RE: Depleted Uranium Performance Assessment (DUPA)
Clive Facility
Model Version 1.4 Amended Interrogatories
Radioactive Materials License #2300249

**UTAH DEPARTMENT OF ENVIRONMENTAL QUALITY
ENERGYSOLUTIONS CLIVE LLRW DISPOSAL FACILITY
RML #UT 2300249**

STATUS OF INTERROGATORIES

Figure 37. Complementary cumulative distribution of HYDRUS and GoldSim infiltration fluxes

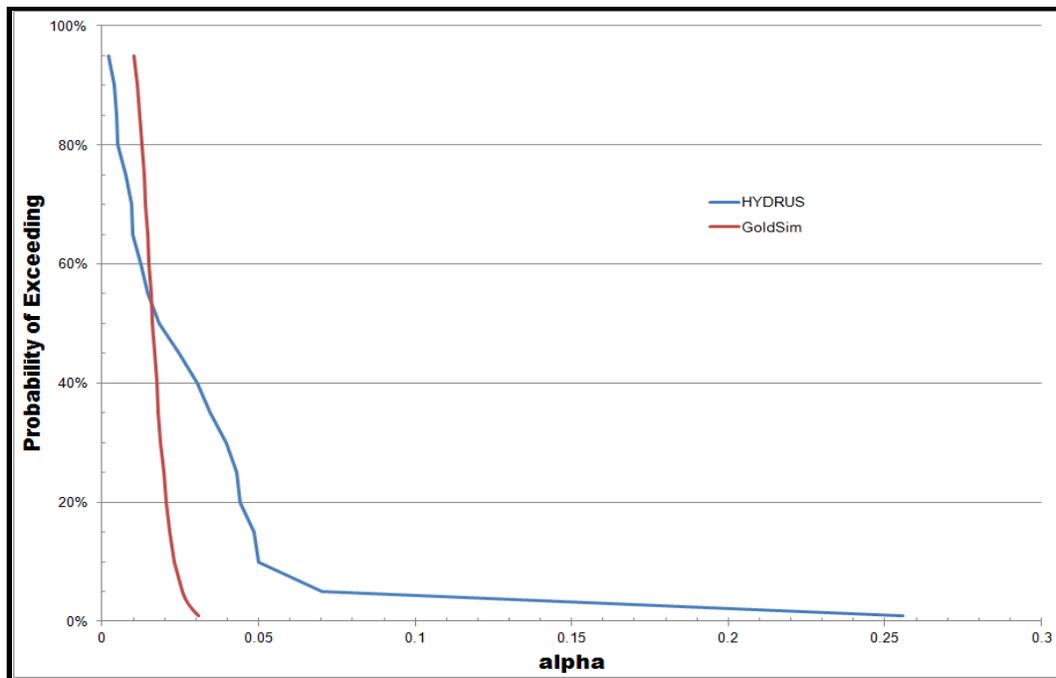
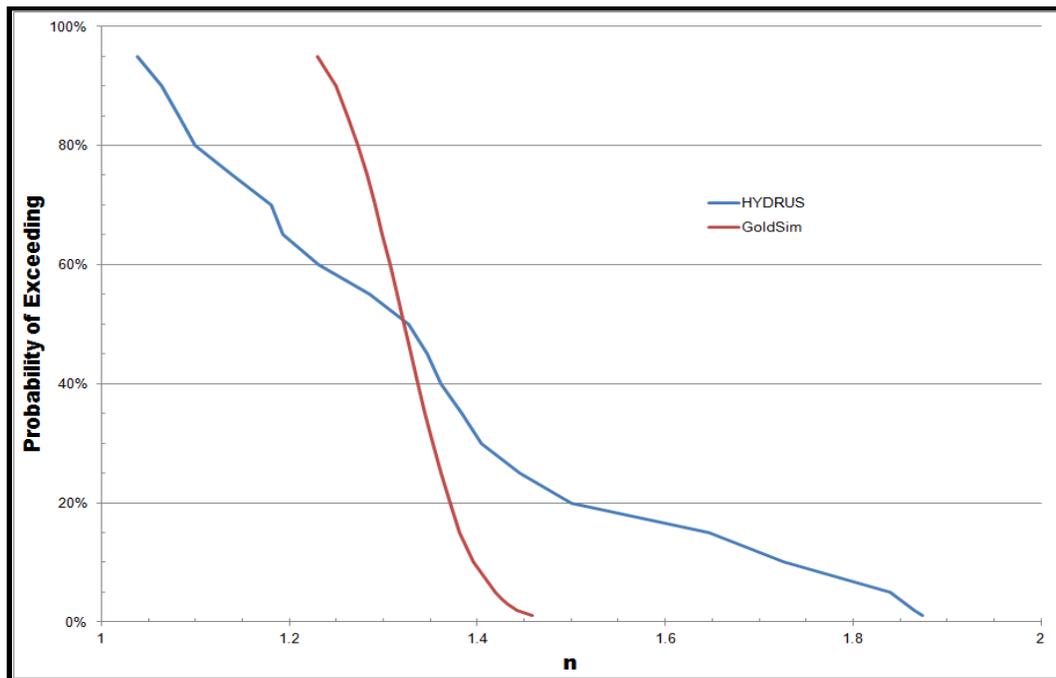
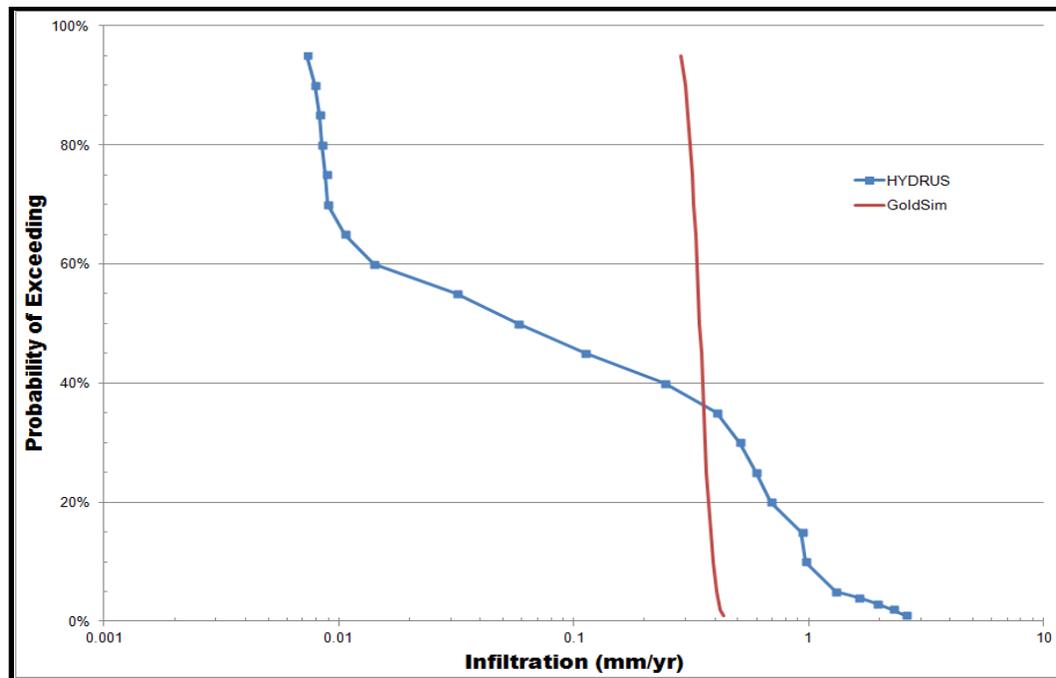
- (2) As acknowledged by EnergySolutions in its responses to Supplemental Interrogatories 1 and 2, due to scaling effects the ranges for α and n that have been programmed into GoldSim are more narrow than those in HYDRUS (i.e., in HYDRUS, α ranges from 0.001883 to 0.3021, but in GoldSim, α only ranges from 0.005 to 0.0493; likewise, in HYDRUS, n ranges from 1.029 to 1.883, but in GoldSim n only ranges from 1.060 to 1.540). See Figure 35 and Figure 36 for complementary cumulative distribution (CCD) comparisons that were prepared by SC&A utilizing EnergySolutions HYDRUS results and the Neptune (2014b), Table 1, GoldSim α and n distributions.

The CCD comparison in Figure 37 shows the effect of these two mathematical considerations on the resulting GoldSim infiltration rate. This infiltration CCD is very similar to Figure 5 of the EnergySolutions response to supplemental interrogatories (ES 2014d), except that it is rotated 90 degrees.
